BRIDGE REPLACEMENT - PPCB

NEW DUAL BRIDGES AS PART OF 4 LANE US 20 PROJECT OVER BOYER RIVER 1.9 MILES WEST OF US 71

REVISION EXAMPLE

NOTICE: This plan revision example is in the MicroStation V8i format of CADD sheets and differs from the MicroStation CONNECT format of CADD sheets. The relevant part of this example to focus on is the use of the revision cloud, crossed out text and details, and the use of the revision triangle.

PIER 2 DETAILS

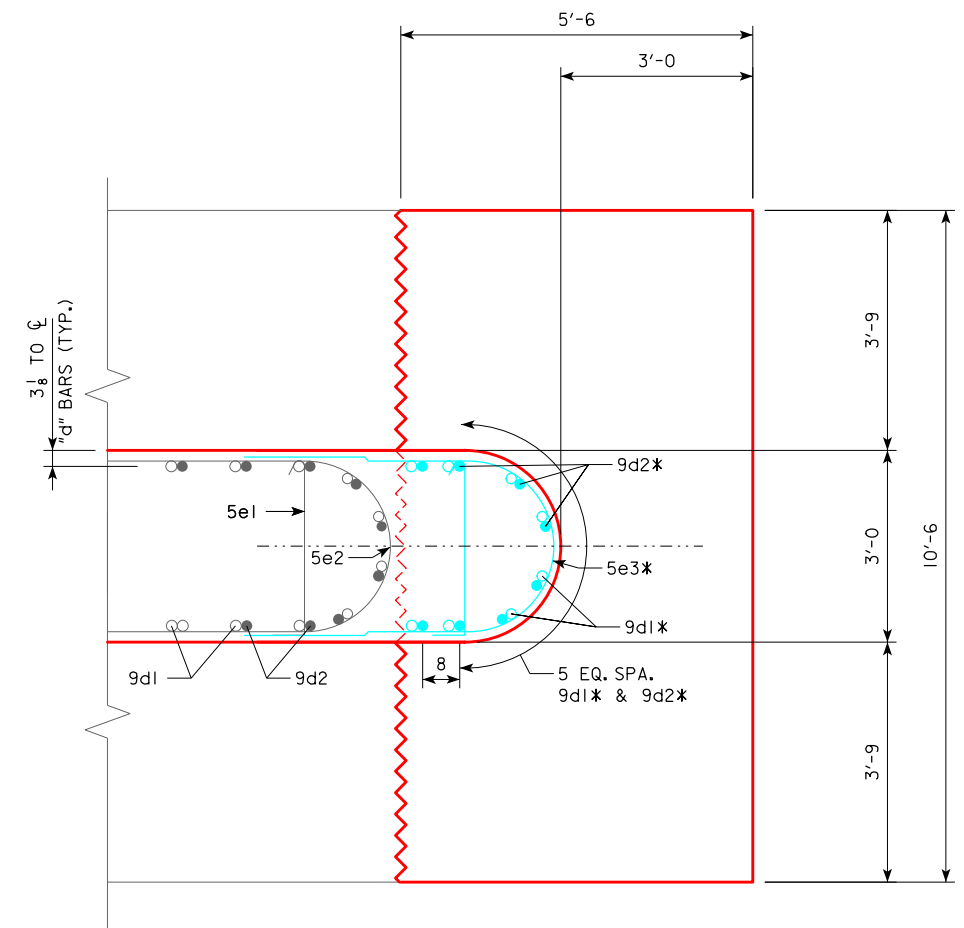
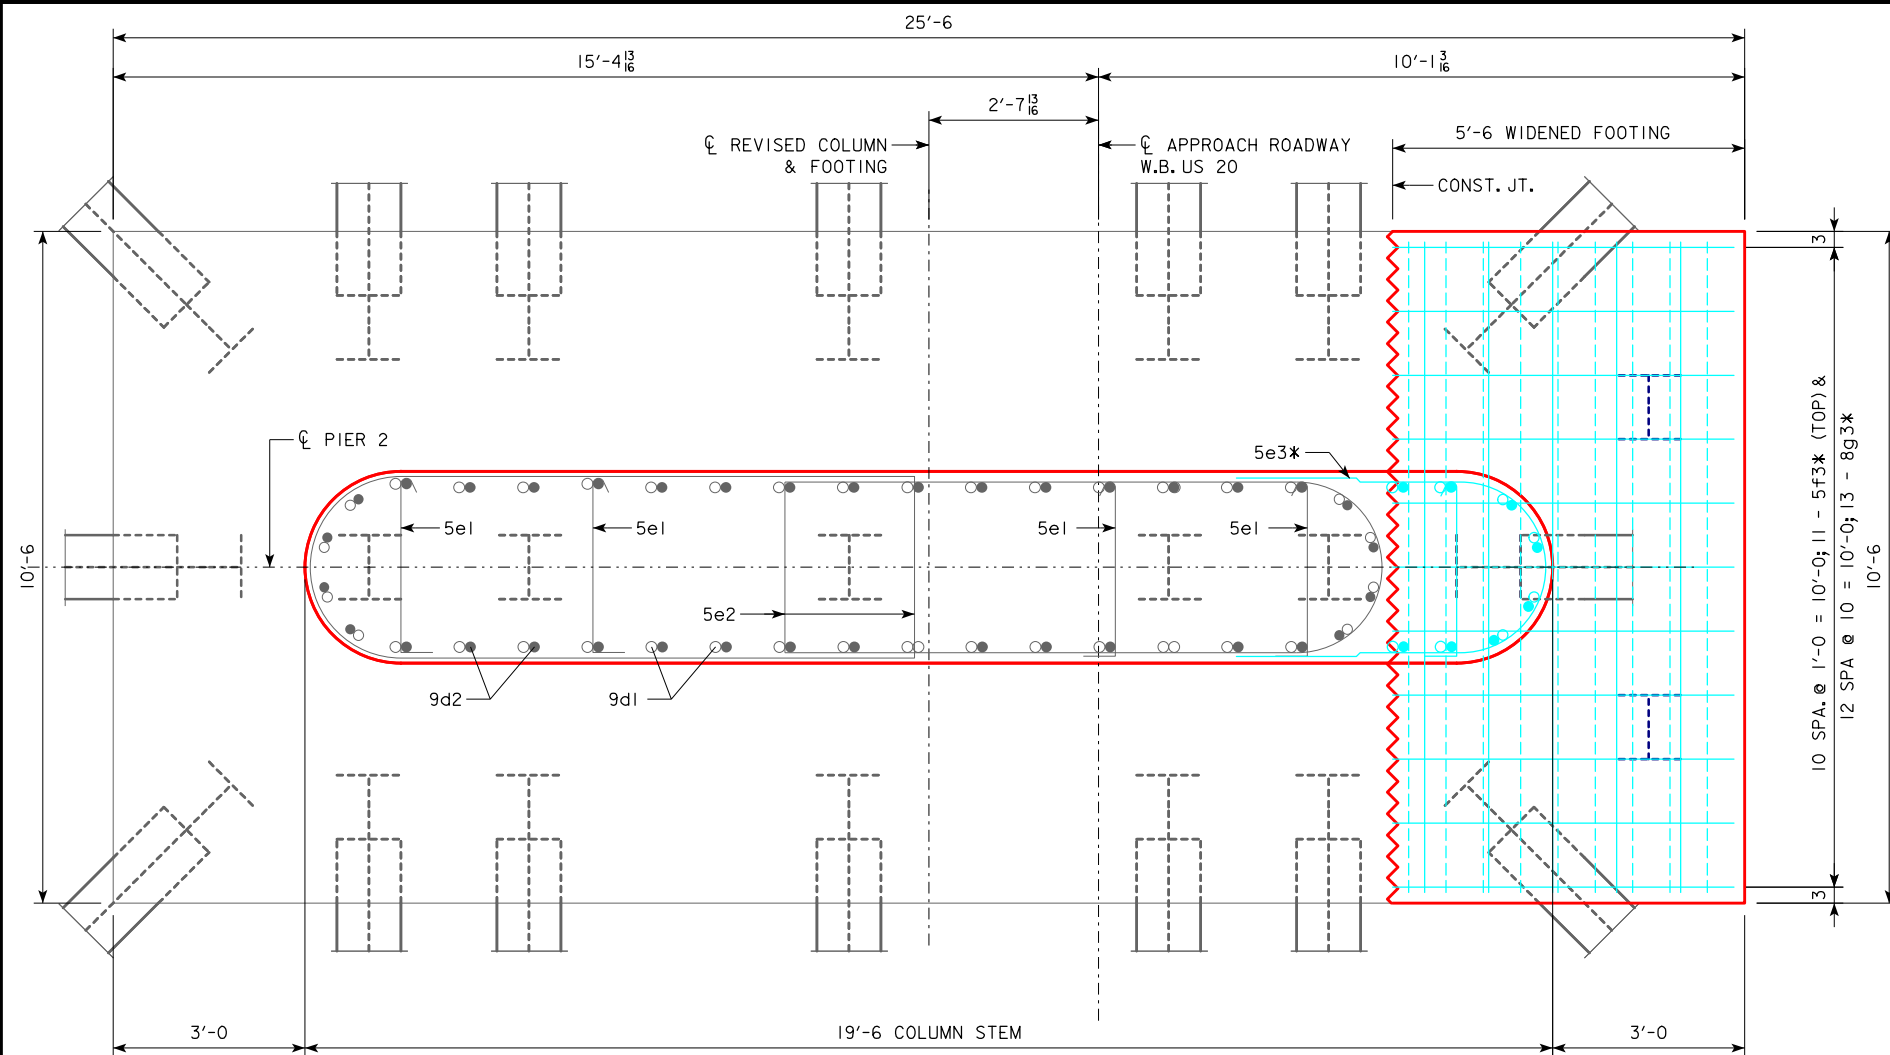
REVISED: 03-09-2017 THIS SHEET ADDED.

REASON: PIER 2 FOOTING MISPLACED 1.4 FT. NORTH OF PLAN ALIGNMENT DUE TO CONSTRUCTION SURVEY ERROR.

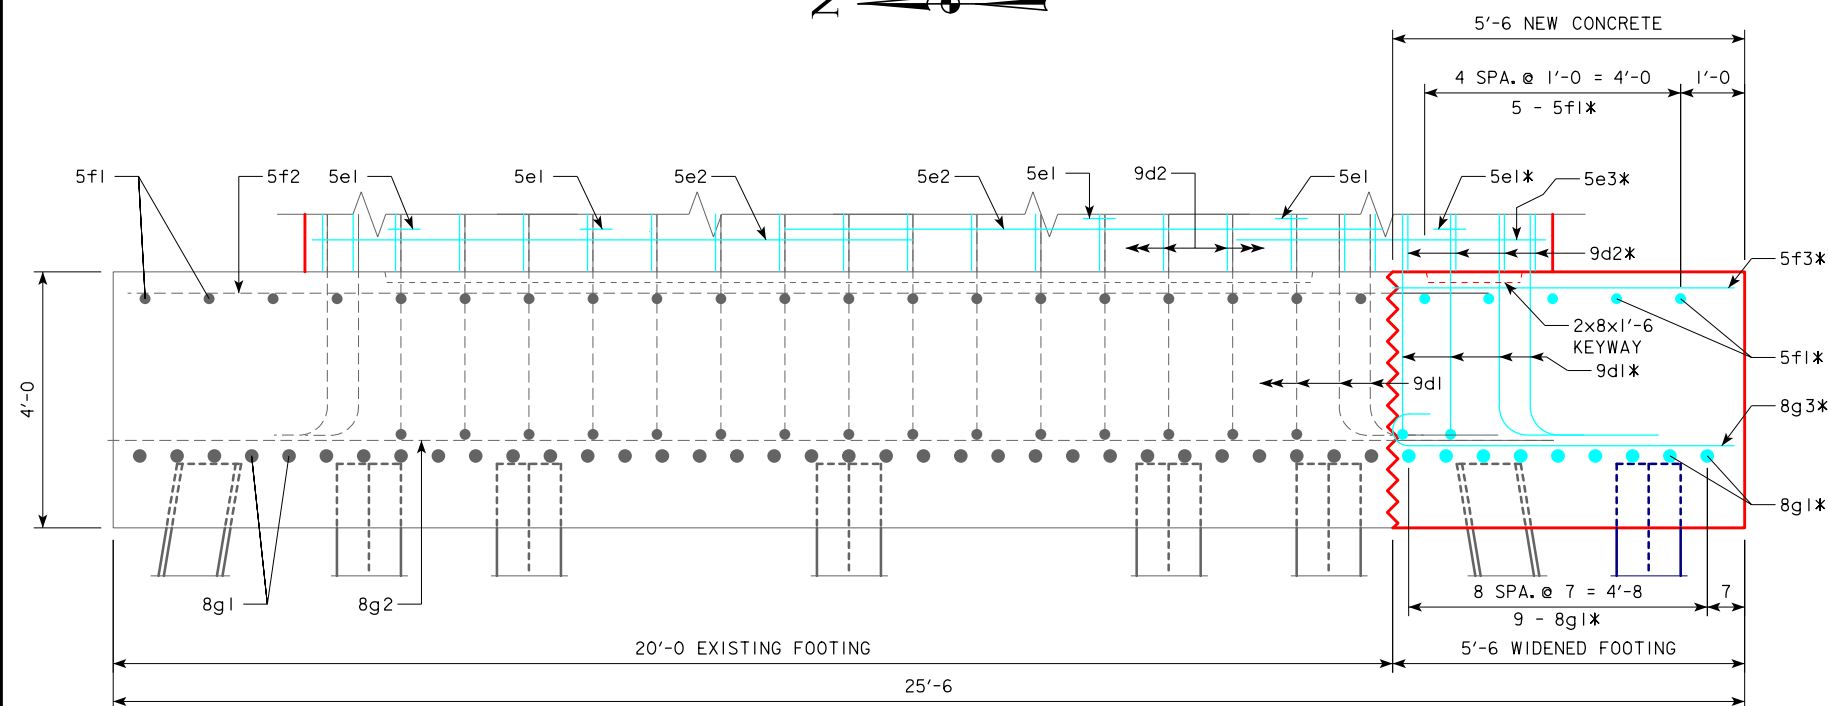
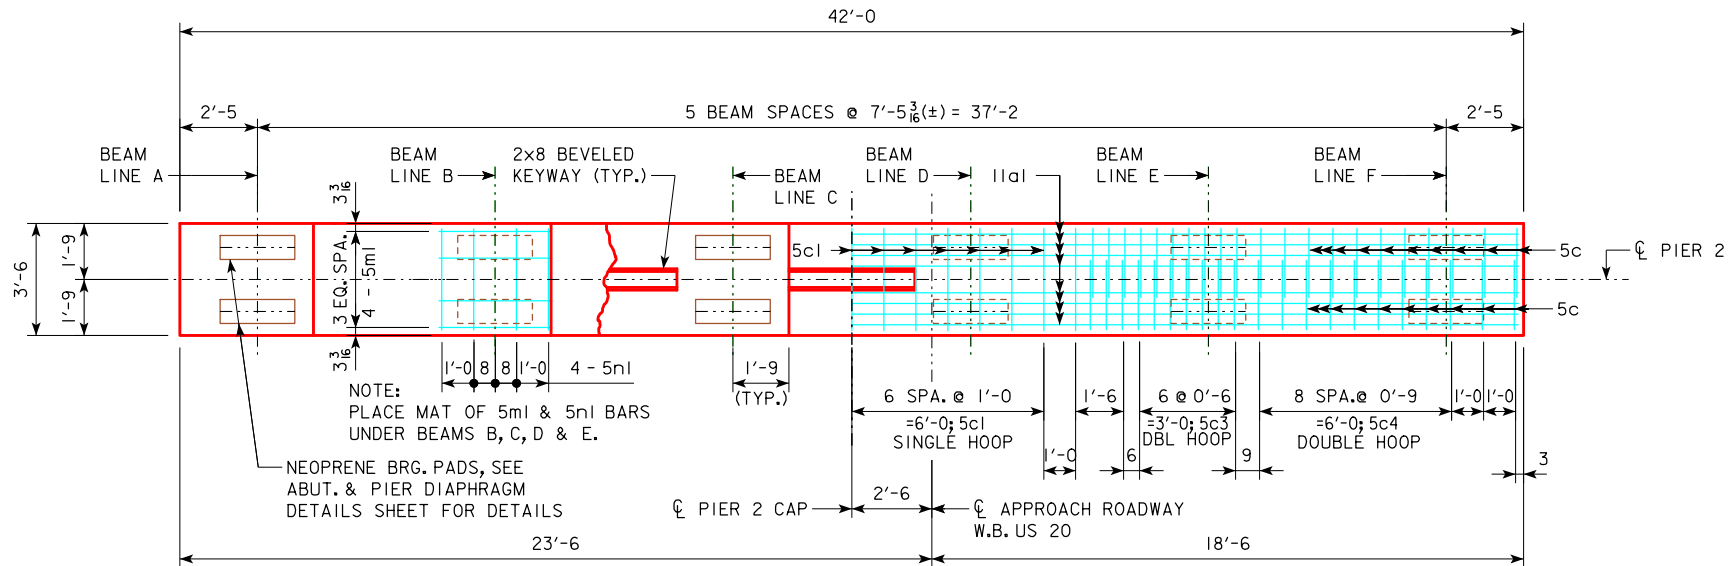
* NOTE:
ADDITIONAL REINFORCING BARS TO BE
PROVIDED. SEE DESIGN SHEET 9 FOR
UPDATED REINFORCING STEEL TABLE.

REVISD: 03-09-2017 THIS SHEET ADDED, PIER 2
FOOTING DETAILS.

REASON: PIER 2 FOOTING MISPLACED 1.4 FT. NORTH
OF PLAN ALIGNMENT DUE TO CONSTRUCTION
SURVEY ERROR.

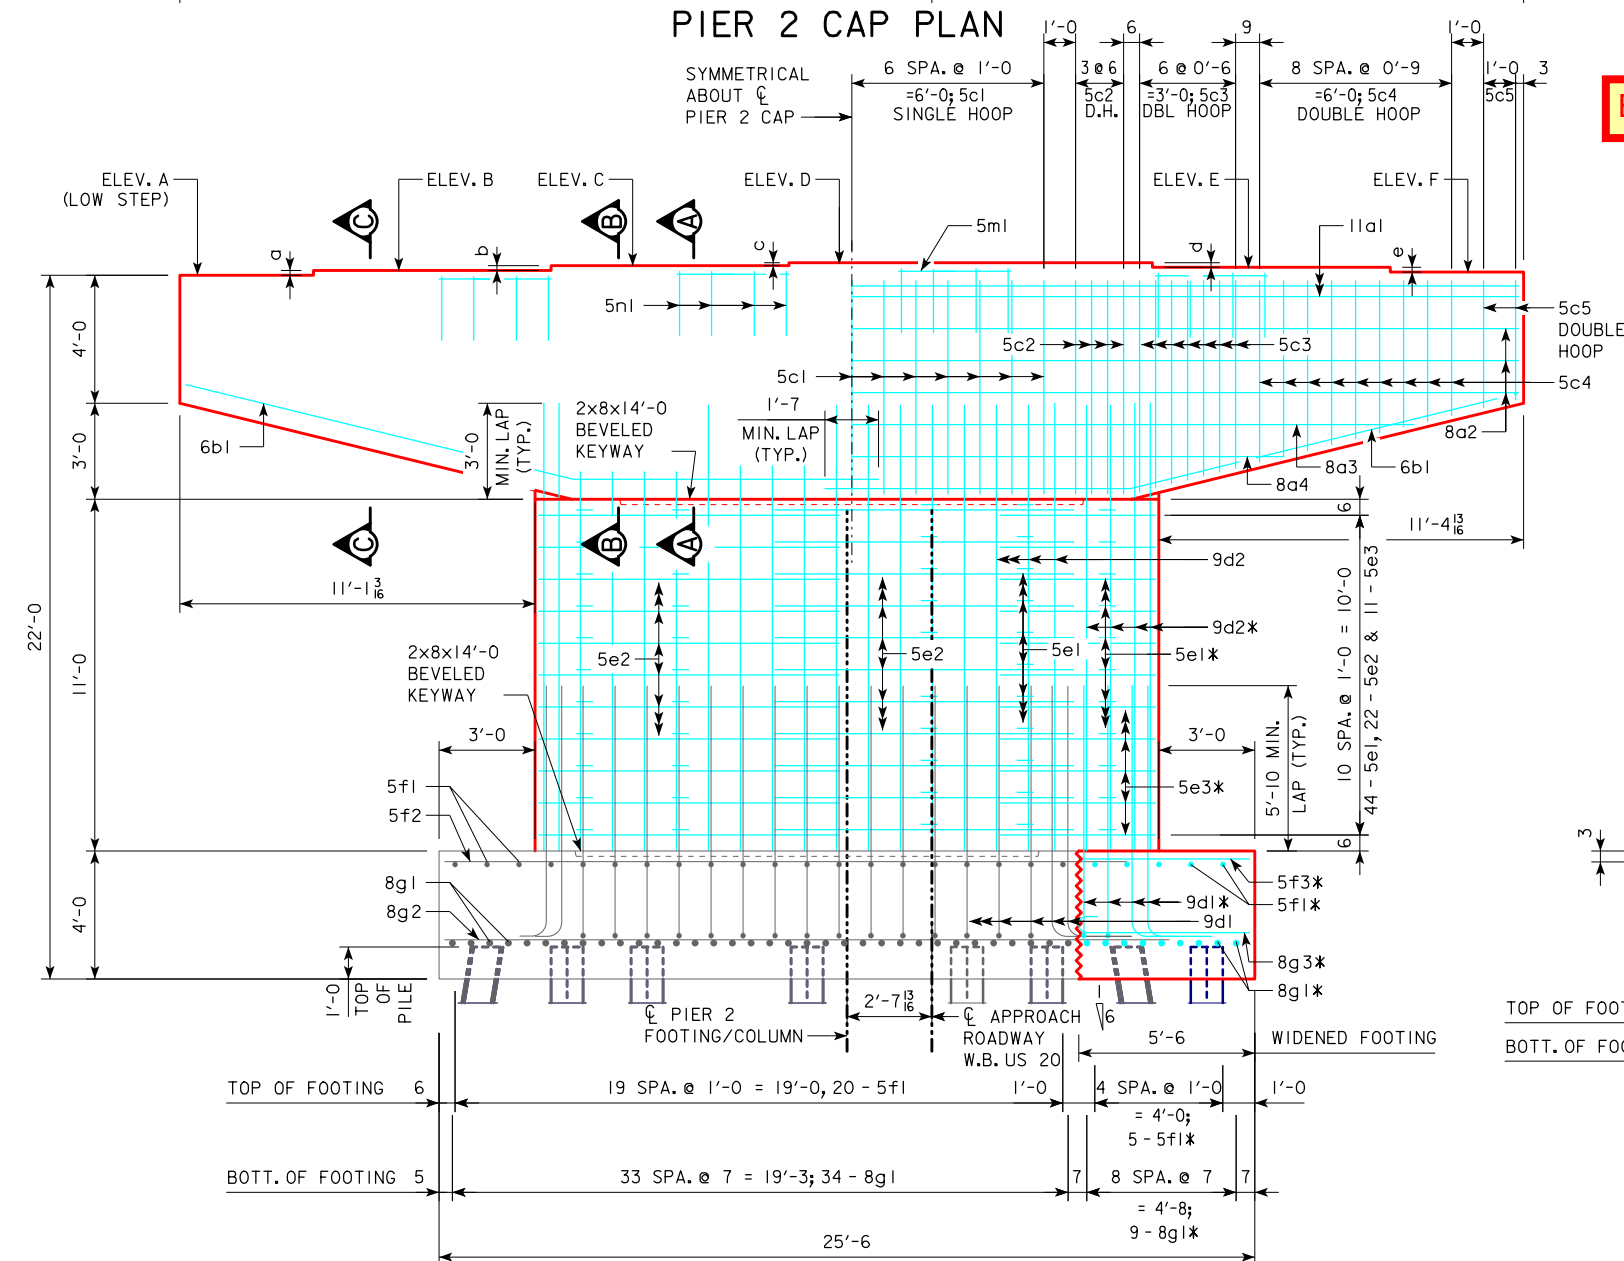
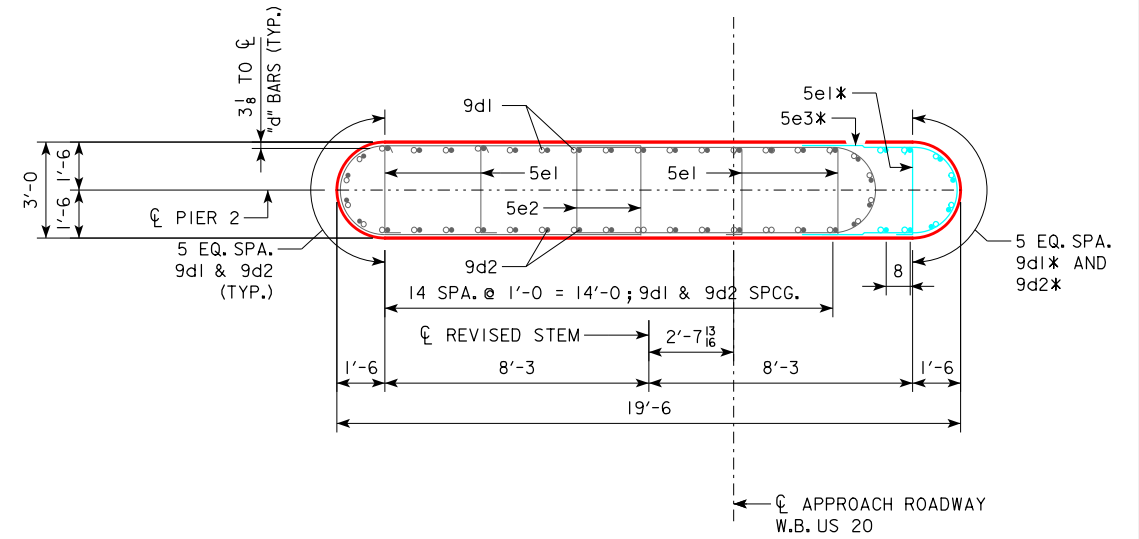
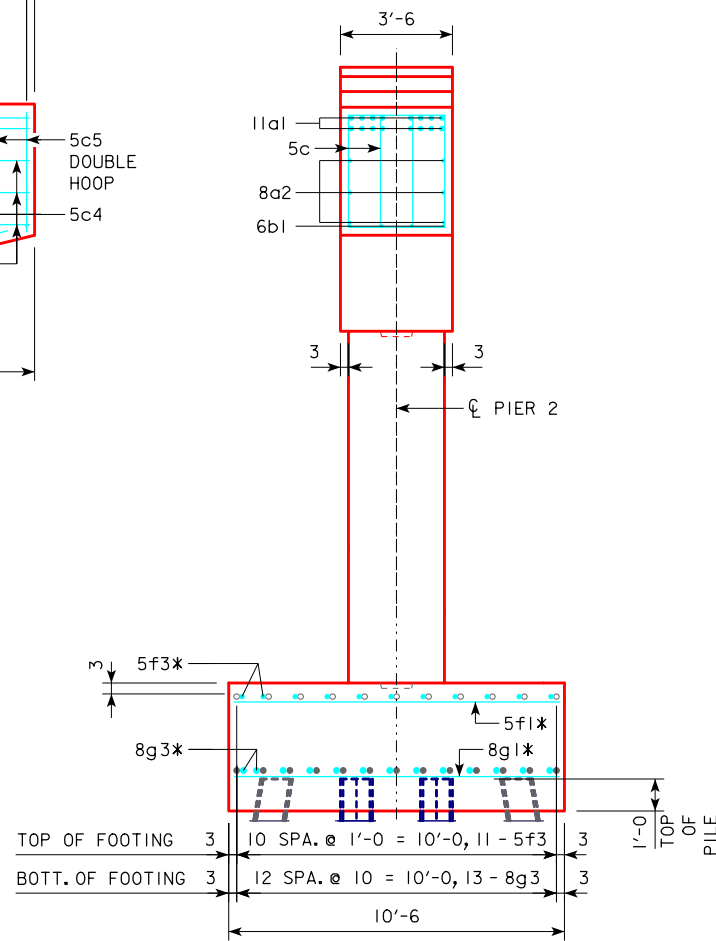
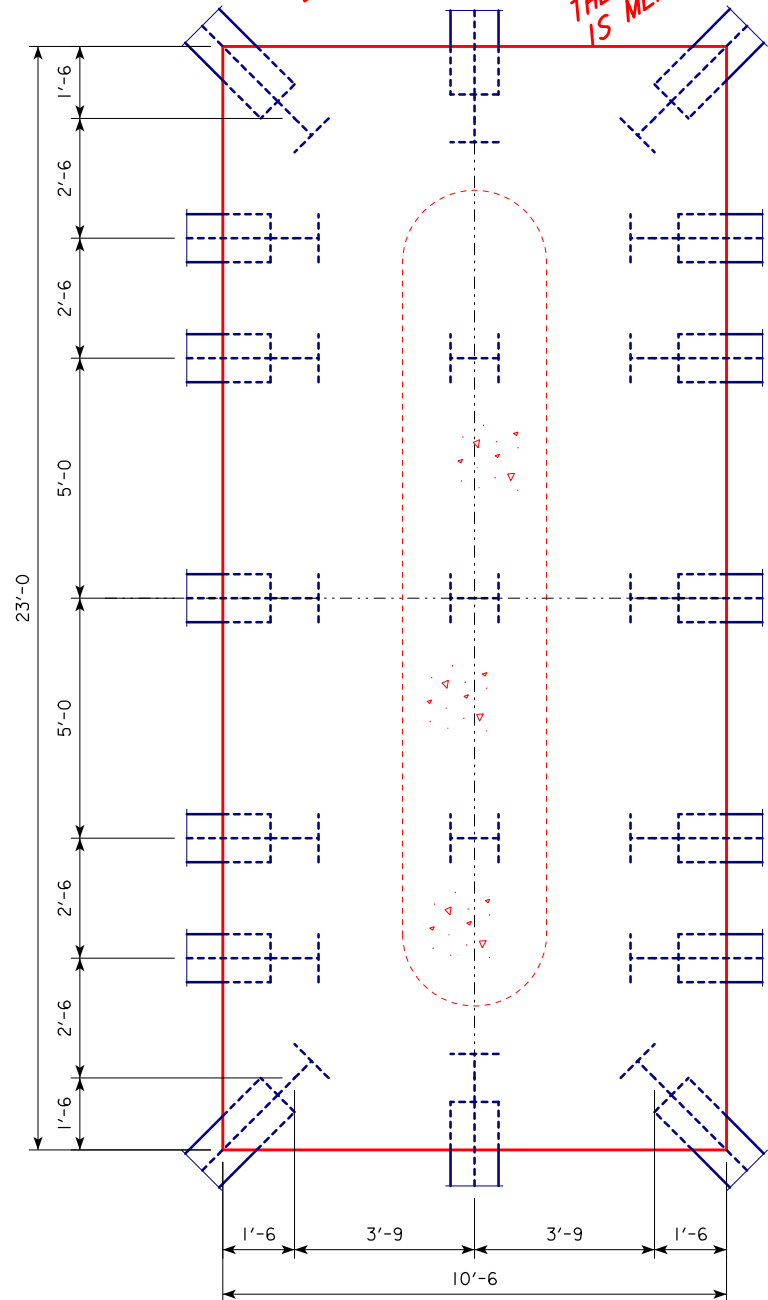
* NOTE:
ADDITIONAL REINFORCING BARS TO BE
PROVIDED. SEE DESIGN SHEET 9 FOR
UPDATED REINFORCING STEEL TABLE.

REVISED: 03-09-2017 THIS SHEET ADDED.
REASON: PIER 2 FOOTING MISPLACED 1.4 FT. NORTH
OF PLAN ALIGNMENT DUE TO CONSTRUCTION
SURVEY ERROR.
